**FEBRUARY 21, 2012 ZONING HEARING
“OTHER BUSINESS”
COMMISSION DISTRICT 3**

To consider a site and stipulation amendment for Walton Communities, LLC regarding rezoning application Z-23 of 2007 (Cherry Hill Investments, LLC), for property located on the north side of Roberts Trail, west of Chastain Meadows Parkway and on the eastern side of I-575, north of Barrett Parkway in Land Lot 581 of the 16th District.

**Proposed Site Plan
Other Business Item 01
February 21, 2012**

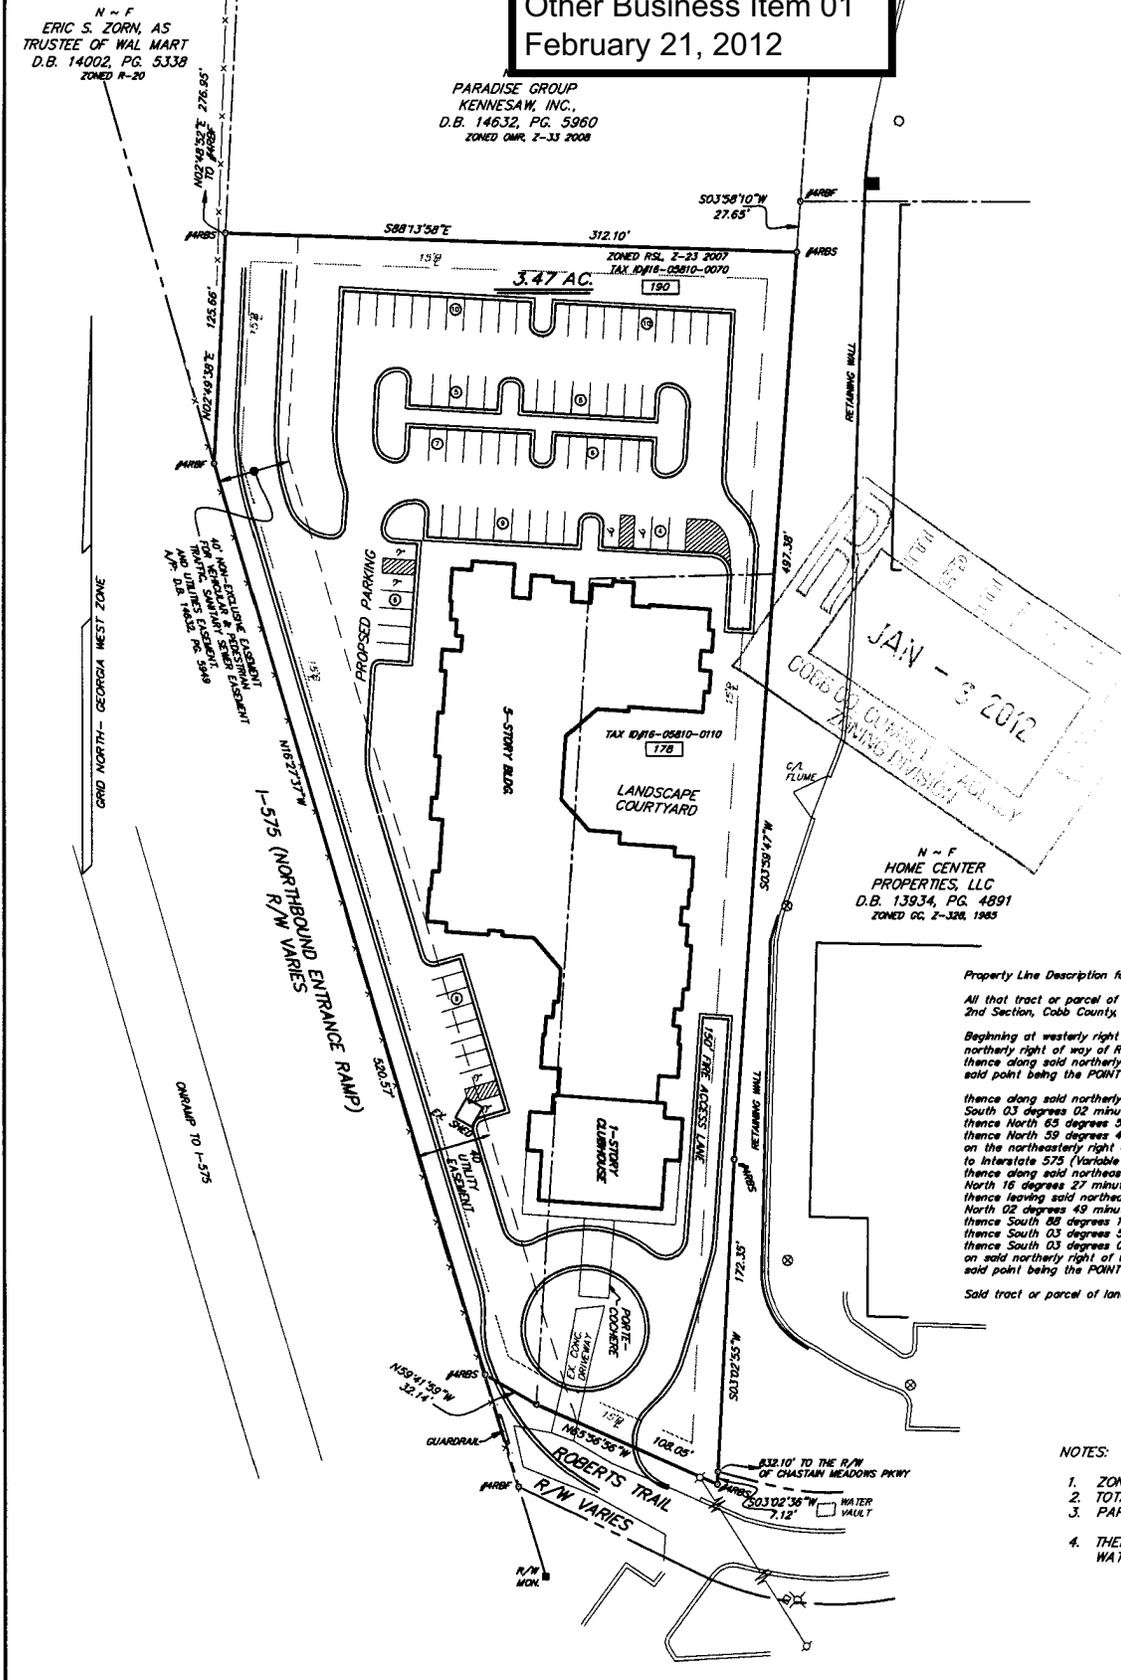
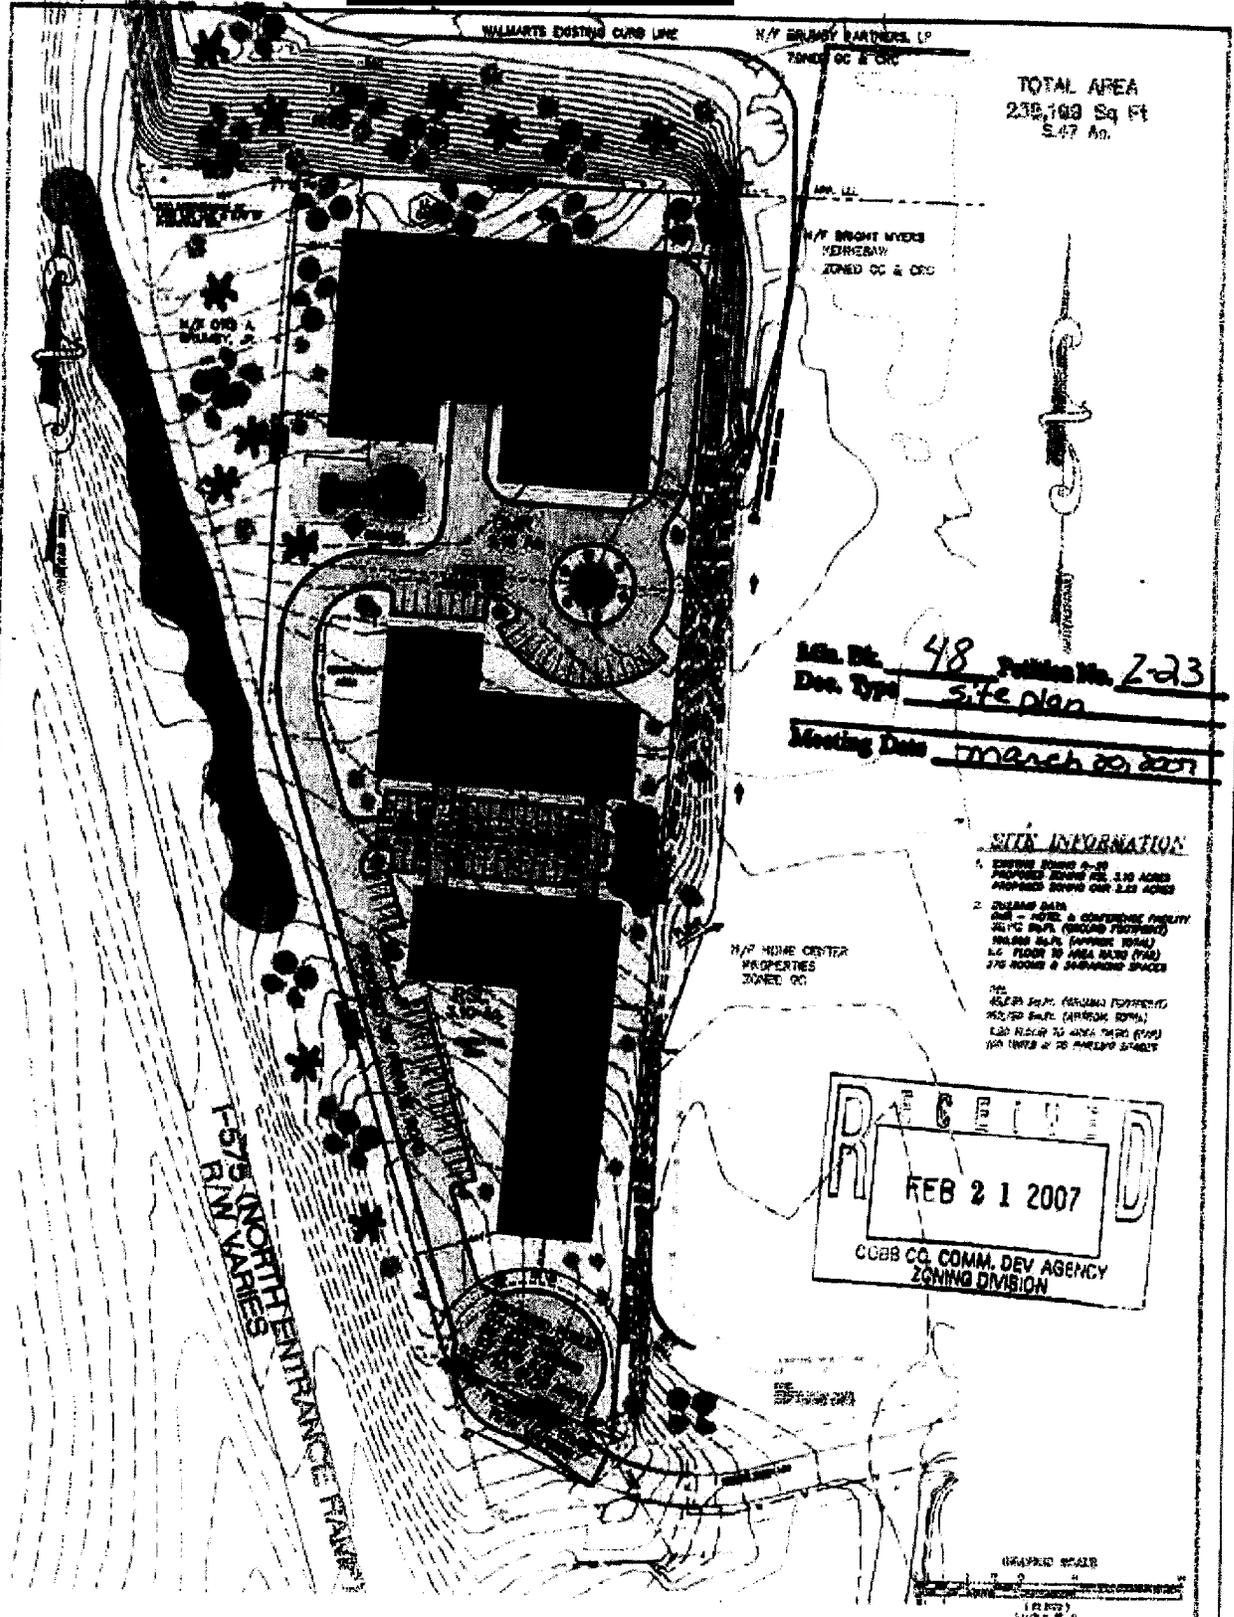
State specifically the need or reason(s) for Other Business: The rezoning was approved subject to the site plan received by the Zoning Division on February 21, 2007, with the District Commissioner being positioned to approve minor modifications. The RSL component of the rezoning provided for two (2) four-story buildings with drive under parking. Walton Communities proposes a five-story building with a one-story clubhouse.
